<b>Company</b>	Trenz Electronic GmbH
<b>PCN Number</b>	PCN-20231110
<b>Title</b>	TE0729-02 to TE0729-03 Hardware Revision Change
<b>Subject</b>	Hardware Revision Change
<b>Issue Date</b>	2023-12-13

## 2.21 #21 Added revision history, block and power diagram. Updated page count and order.

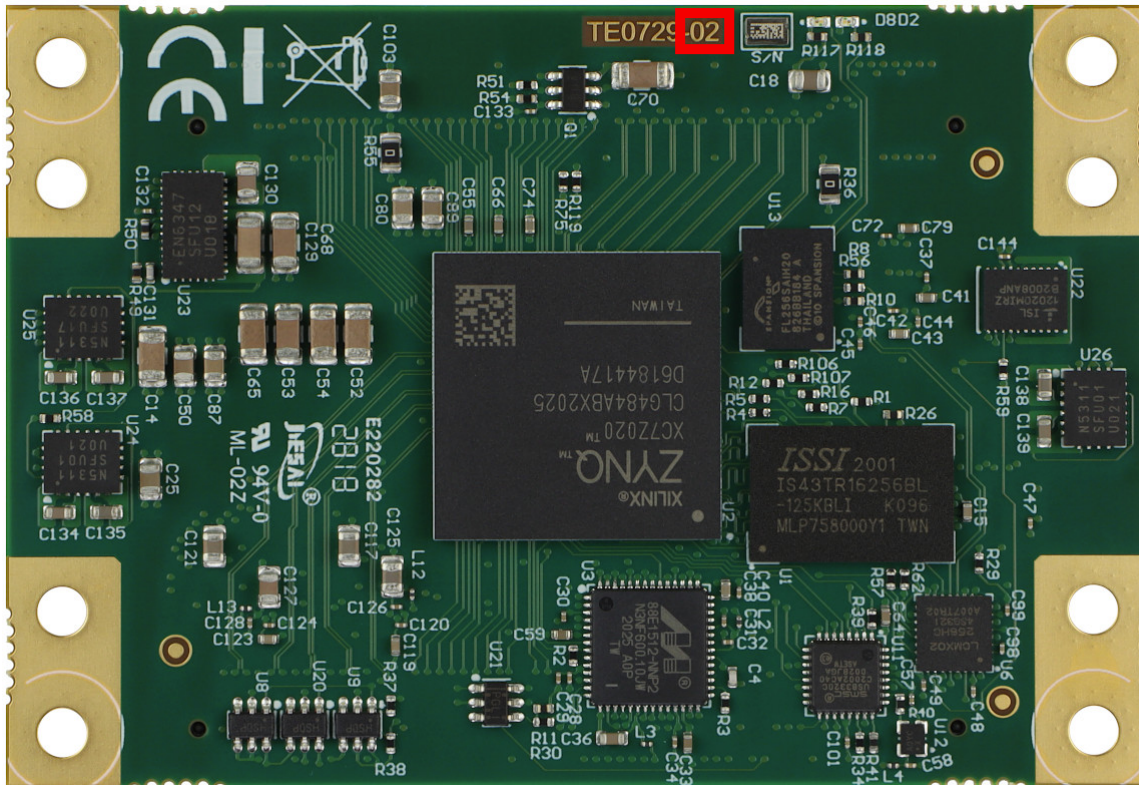
**Type:** Documentation Update

**Reason:** Documentation improvement.

**Impact:** None.
